SERVICE BULLETIN

98- T3.05

MODEL CONCERNED: All Tractors

Printed Circuit Boards

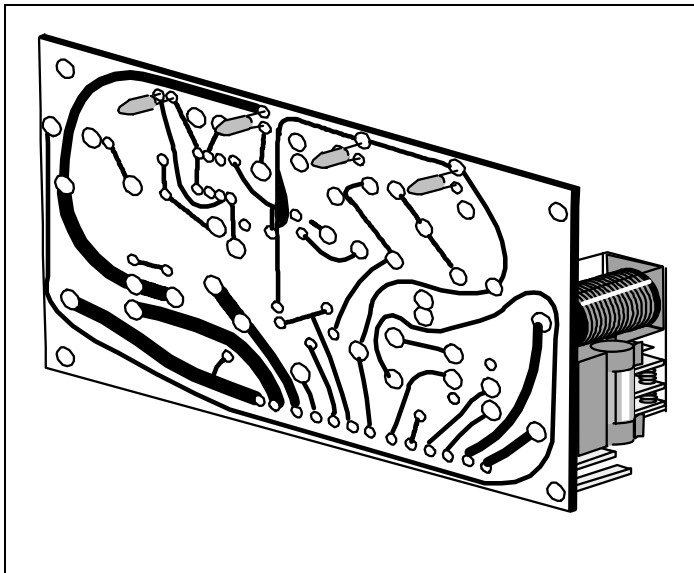
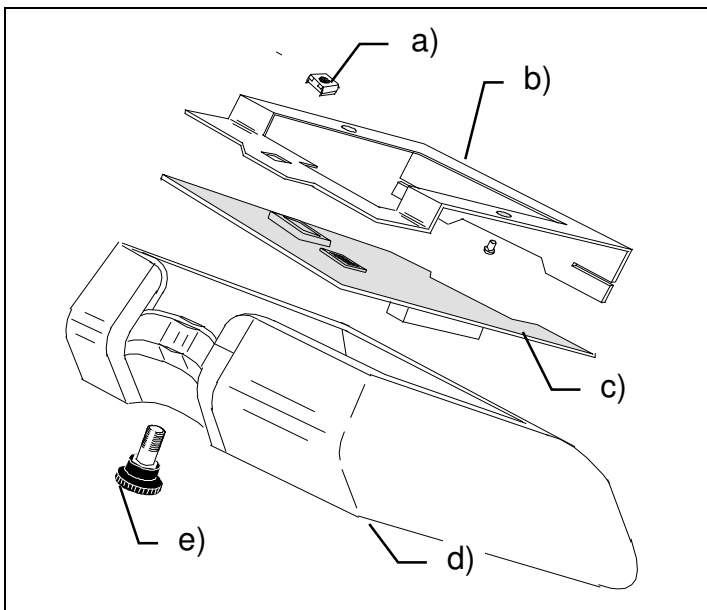
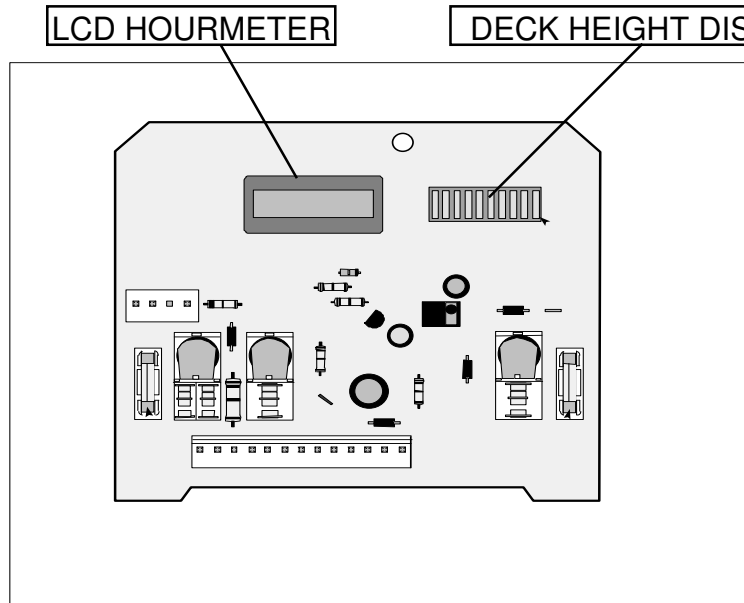
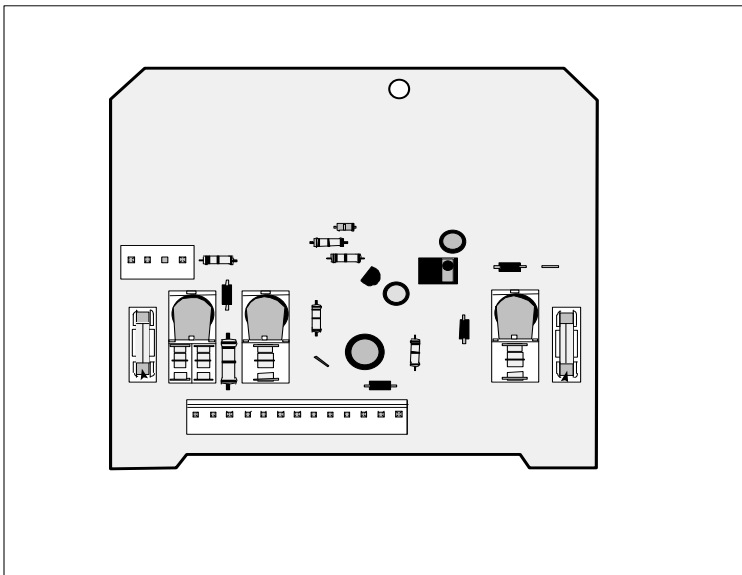
The new printed circuit board operates in exactly the same way as before. However they are not retro-fit as the fixings are different.

New layout for all

tractors (inc. A20/50)

a)	M5captive nut	04928600
b)	PCB support bracket	302002500
c)	PCB	(as shown)
d)	PCB Cover	1480032000
e)	Retaining Screw	028000500

Electric Actuator Lift tractors (inc.
A20/50)

after Serial No. 80326.....

Standard tractor (non-HE)
after Serial No. 80326.....
